**An Coimisiún Pleanála [ACP] Case Numbers:  
ACP-323996-26 and ACP-324000-26**

**Proposed development N70 Waterville to Ballybrack Road Improvement  
Scheme Townlands of Waterville, Ballybrack and Eightercua, Co. Kerry**

**KERRY COUNTY COUNCIL [the Council]**

**Response to Submissions**

**Figure 5.2.1: Section B- B in Figure 6 of the McCutcheon Halley submission**

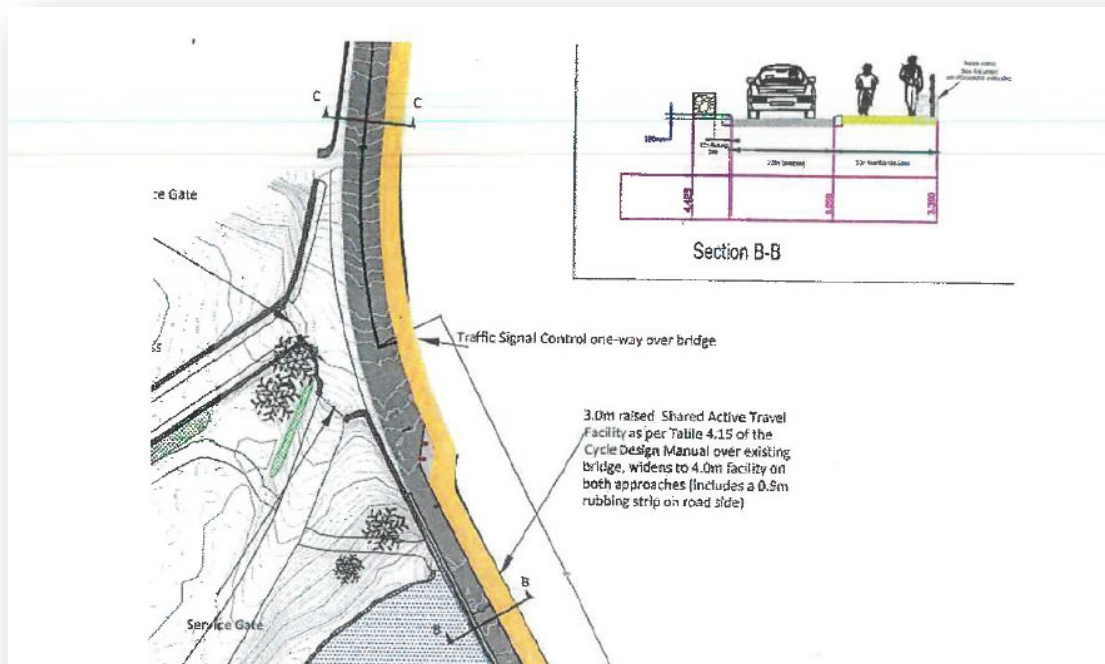
- Page numbered 27 of McCutcheon Halley submission appears to show the bridge parapet wall removed in section B-B and Vehicle Restraint System (VRS) or safety barrier installed.

Figure 6 of the McCutcheon Halley submission contains an extract from the MHL report showing the alternative option. Section B-B of Figure 6 is a cross section of the existing Currane River Bridge. It shows the existing stone bridge parapets, with a note on the eastern parapet stating *“Replace existing Stone Wall parapet with VRS / pedestrian safety railing”.*

In respect of the statements highlighted above in the same McCutcheon Halley submission, the Council submit that the demolition of the existing stone parapet on the historical heritage asset of Waterville Bridge would have a detrimental effect on the heritage value of the structure and the visual impact of the demolition would be more than substantial, with the introduction of a VRS or pedestrian safety railing at the edge of an old stone arch bridge. This is a significant intervention and alteration that is being proposed to the existing bridge.

Demolition to the existing parapet would necessarily involve in-stream works to create a working platform on the outside edge of the bridge. It would also require the closure of the N70 to create working space on top of the bridge to implement the works required to demolish the existing stone masonry parapet and construct the necessary foundations for a new VRS/pedestrian safety railing. These works would introduce additional risk of deleterious materials entering the river and the SAC with consequent impacts on the qualifying interests.

**Figure 5.3.1: Section B- B in Image 5 of the MHL submission**

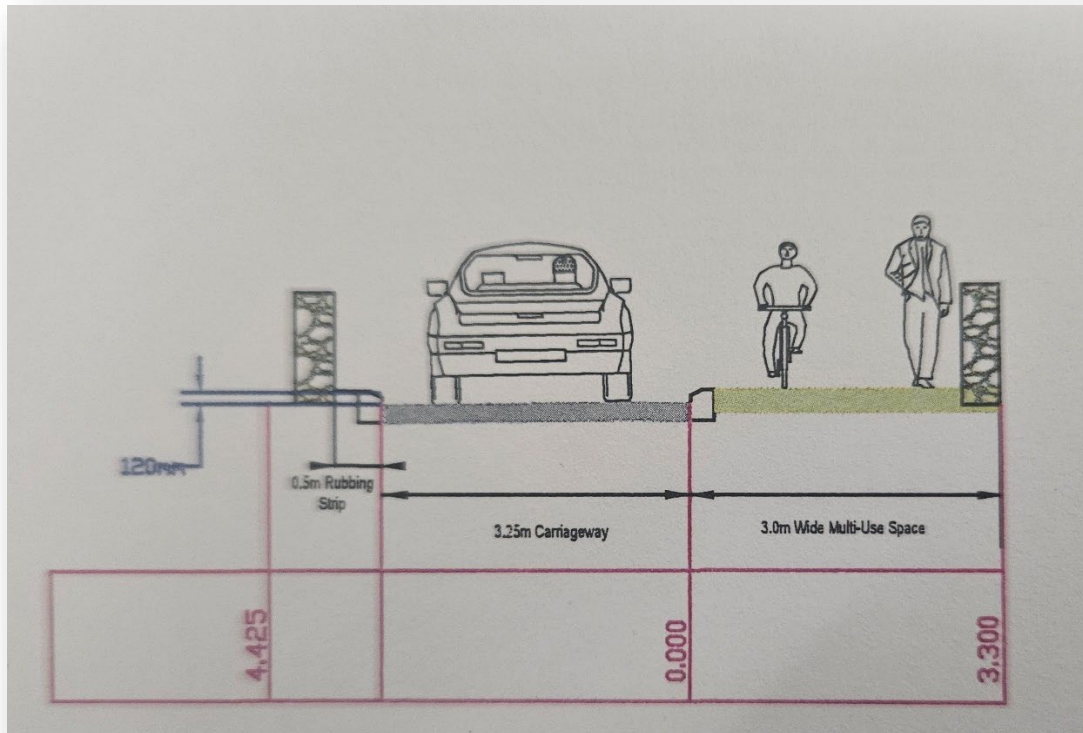
Image 5 of the MHL report and the accompanying drawings also have a Section B-B which, similar to the McCutcheon Halley submission is a cross section of the existing Currane River Bridge. However, the MHL report does not appear to show the eastern parapet being replaced with a VRS/pedestrian safety railing. Instead, the MHL cross section shows both parapets being extended in height and made narrower than the existing parapets.

The MHL proposal does not meet the current standards for the provision of cycle facilities. The Cycle Design Manual Table 2.2 requires an absolute minimum of 0.5m inside clearance to the bridge parapet (A) + 3m shared facility (B) + 0.2m outside clearance (C) + a buffer of 0.3m (D) assuming a speed limit of <50kph is allowed, giving a total width of 4m. This is the absolute minimum width required to meet current standards and this would leave only 2.25m for the carriageway in the MHL cross section above.

**Figure 5.3.3** *Soldier Course (above the red line) would require removal and reconstruction*

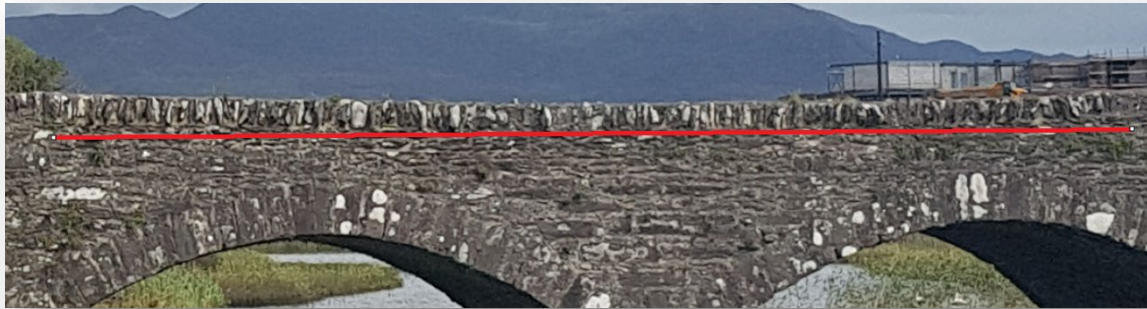
Raising the existing parapet walls (even without needing to narrow them) would involve the removal of the soldier course of vertical coping stones at the top and then addition of new stonework above the existing stonework before (presumably) reinstating the coping stones at the top. This would result in irreparable damage to the aesthetic of the old bridge. A visible joint between old and new stonework would be visible with different colours, textures and workmanship clearly visible for posterity. The existing stonework is a random rubble type which would be extremely difficult to replicate.

It is not possible to extend an existing masonry structure without affecting its heritage value. The result would be a hybrid [old and new] version of the previous bridge and its heritage value at present.

Figure 5.3.4 MHL Alternative Proposal – Plan View

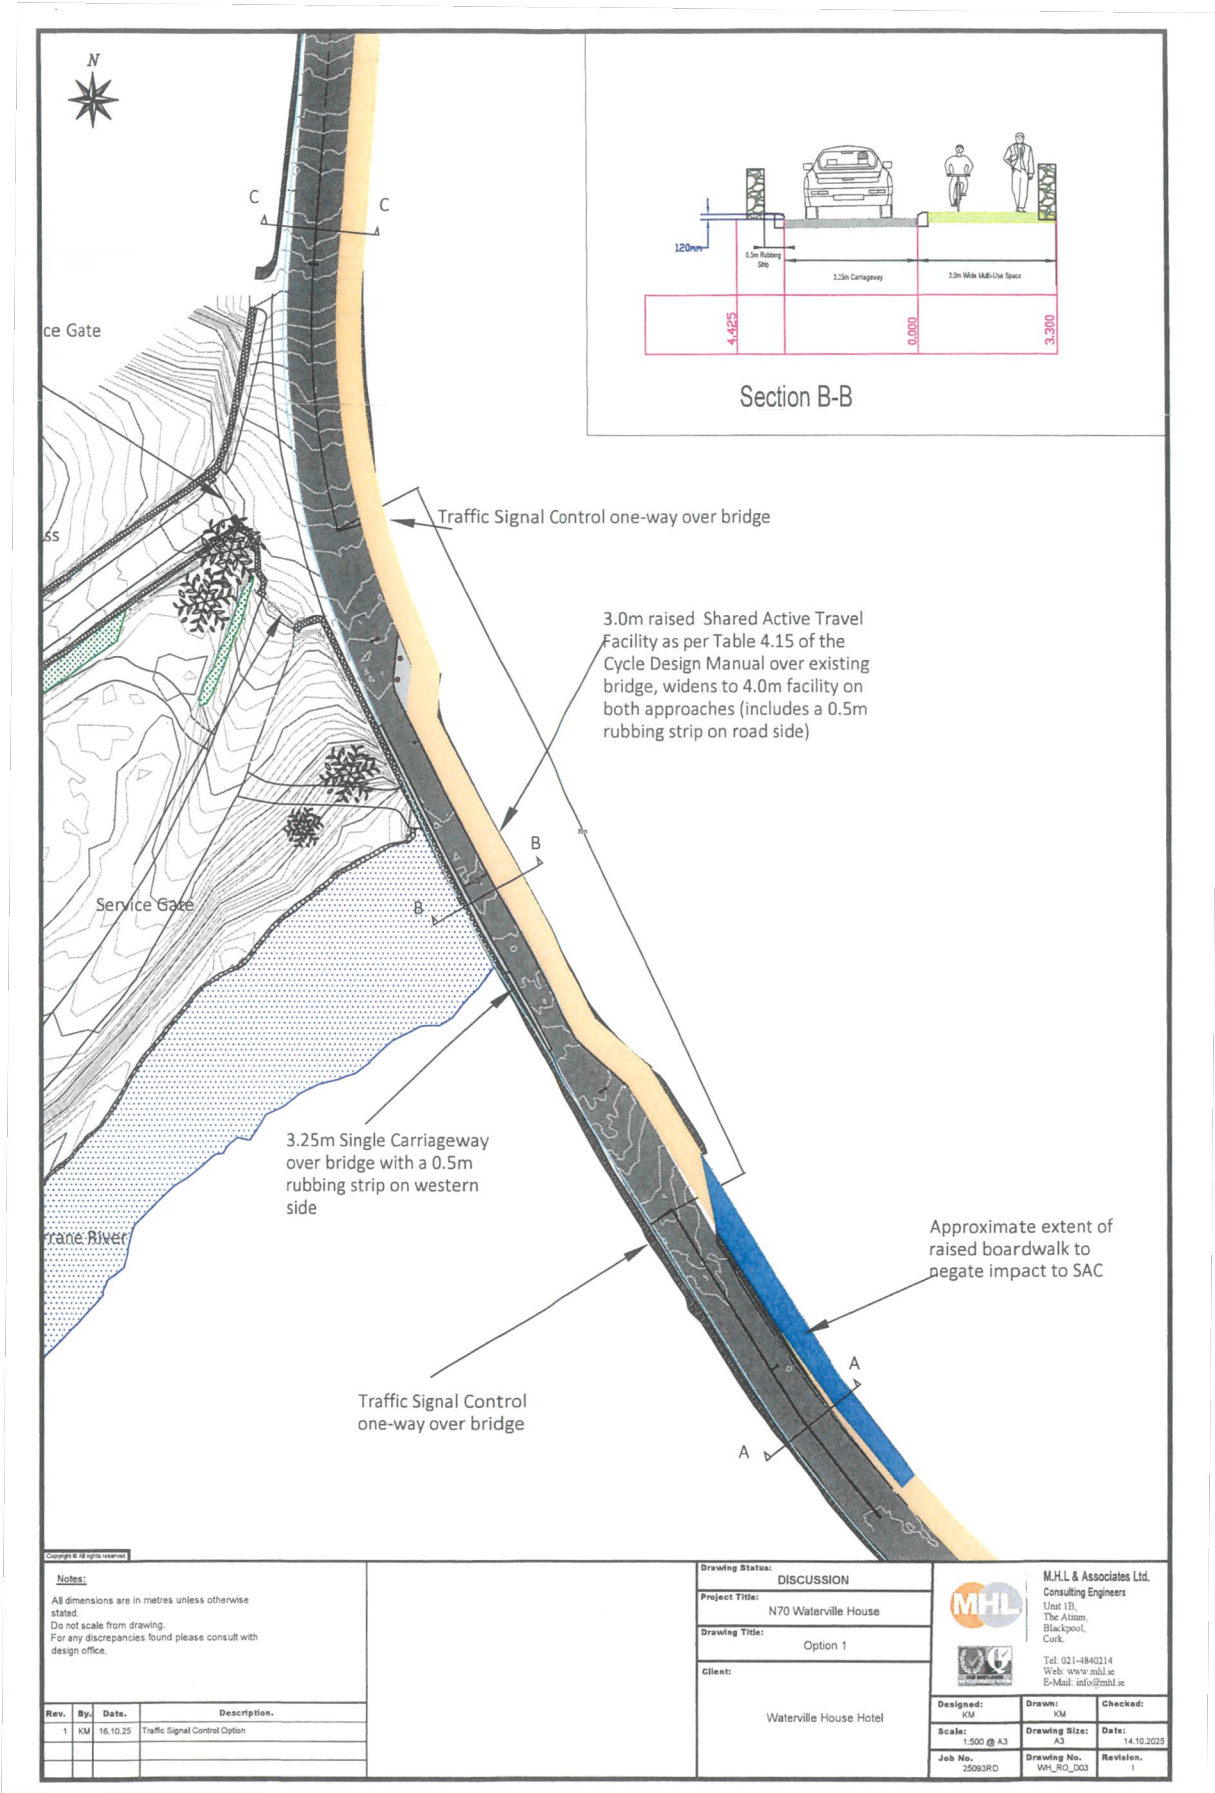
The MHL report states that *“construction will not require the closure of the N70”*. This is rejected as the MHL option requires significant work to the existing bridge, as the parapets need to be partially demolished and reconstructed which will require working space on the narrow bridge, and construction of the new kerbs on both sides of the proposed carriageway as well as the new shared pedestrian/cyclist path will require the full closure of the N70 as it is not possible to fit the required construction machinery and plant onto the existing bridge whilst catering for traffic (including buses and HGVs).

The proposed development submitted to An Coimisiún Pleanála by The Council requires no work to the existing bridge, and most of the work remote from the bridge is offline. It is therefore entirely possible to complete the proposed scheme without requiring a full closure of the N70, except for a single short duration overnight closure to lift the new footbridge into position.

**Figure 5.4.4.2 Cross Section width indicated does not fit between the existing bridge parapets**

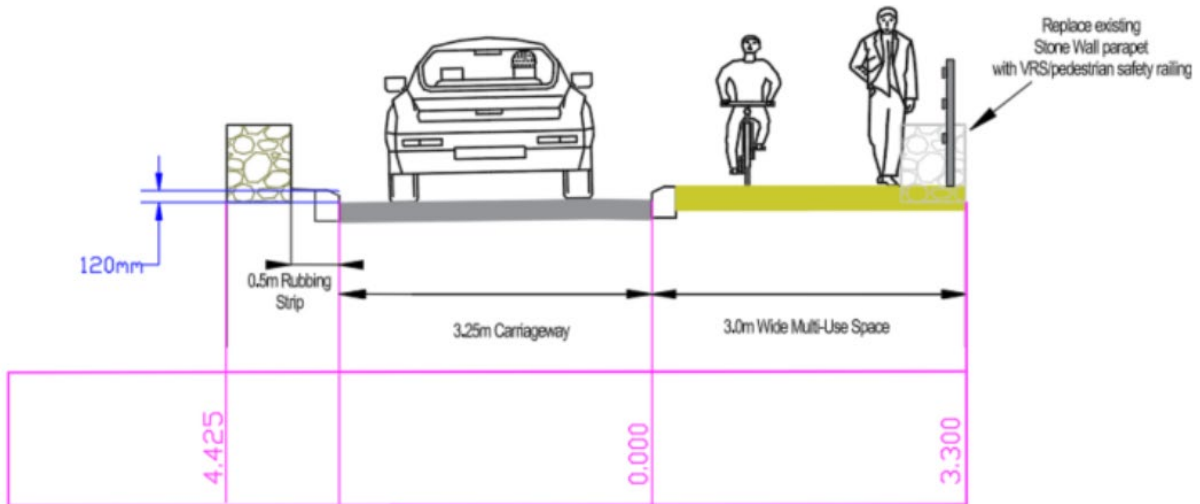
- Applying these standards, the proposal does not fit on the existing bridge and would require widening.
- The cross section as shown on the submission does not fit on the existing bridge which has a minimum wall-to-wall measurement of 6.27m.

**Fig 8.3.1 – Google Maps Screenshot 2022**

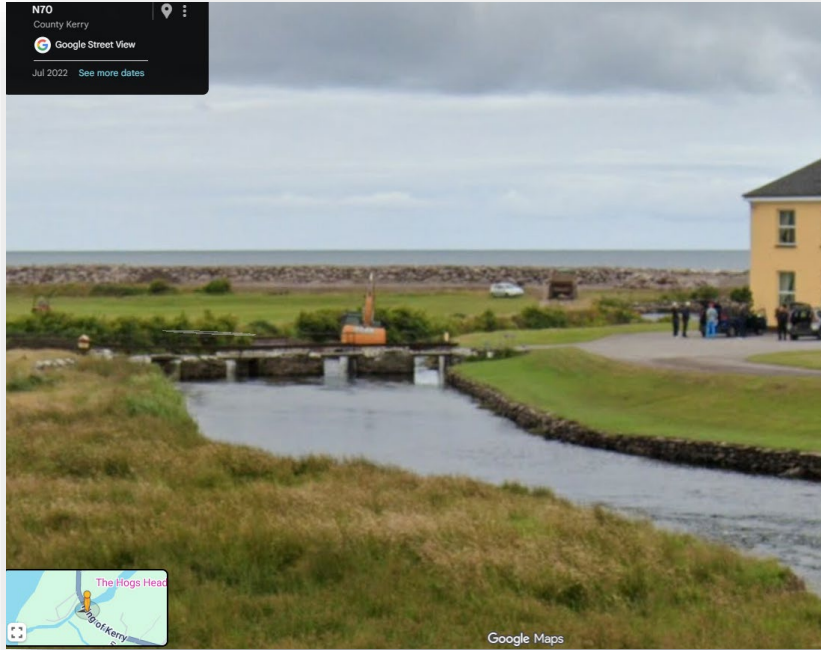
Google Maps Streetview appears to show works immediately adjacent to the weir in 2022. An excavator appears to be in the Currane river near the weir and there appears to be machinery in the background.
